# **SERVICE LETTER**

### HC-SL-30-246

## **De-Ice - Spare Parts Release**

Hartzell PHC-J3YF-2()/FC7663K-2R aluminum hub, compact propellers installed on Raytheon 58 Barons equipped with propeller de-ice are affected by this Service Letter.

Areas of Damage Figure 1

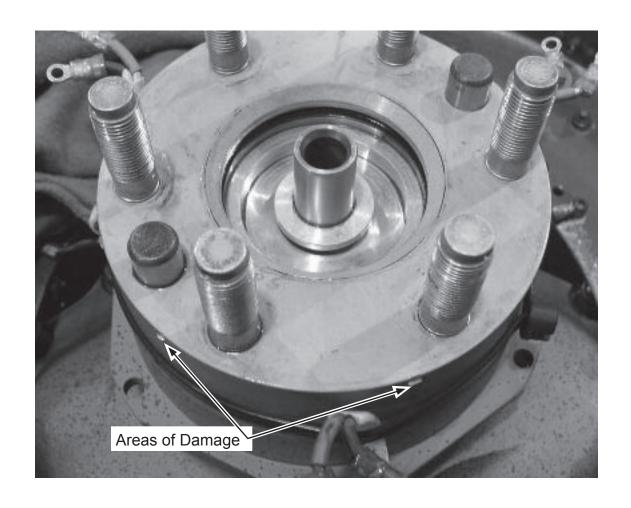
- Numerous reports have been received concerning the propeller hub damage. Investigation indicates that the damage was caused by contact between the hardware used to attach the slip ring to the de-ice split mounting plate and the propeller hub. The diameter of the hardware specified for attaching the slip ring to the de-ice split mounting plate may be too large resulting in the contact.

- (3) The damage appears as small indentations on the outside diameter of the propeller hub extension surface. See Figure 1.
- (4) New hardware is required for attaching the slip ring to the de-ice split mounting plate. Attachment of the slip ring to the de-ice split mounting plate using the new hardware prevents further damage to the propeller hub.

- A. Hub Inspection
  - (1) If no damage to the propeller hub is visible, proceed to Paragraph 3.B.
  - (2) If damage to the propeller hub is visible:
    - CAUTION 1: DAMAGE DEPTH OF 0.020 INCH (0.508 MM) IS PERMITTED

- (a) Lightly file or polish the hub to remove the damage. Raised area must smoothly blend with the undamaged surrounding area and have a depth to width ration of at least 10. Raised material is not permitted. Rework is permitted to a maximum depth of 0.020 inch (0.508 mm) with a surface finish of Ra100 or better.

- (3) If individual damage or rework depth is greater than 0.020 inch (0.508 mm) depth, hub must be retired from service in accordance with the Parts Retirement chapter of Hartzell Standard Practices Manual 202A (61-01-02).
